BELL SYSTEM PRACTICES Plant Series

ADDENDUM 030-360-801 Issue 1, February 1971 AT&TCo Standard

1-TYPE MESSAGE TICKETER PIECE-PART DATA AND REPLACEMENT PROCEDURES

Fig. 6—₱Printing Mechanism (bottom view)♠

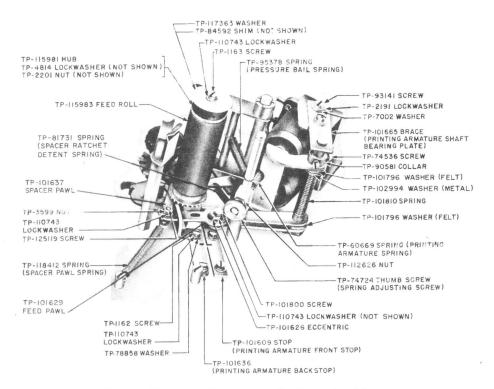
1.002 This addendum is issued to add two piece-part numbers to Fig. 6.

- (a) Fig. 6—Piece-part TP-101629, Feed Pawl, added.
- (b) Fig. 6—Piece-part TP-101637, Spacer Pawl, added.
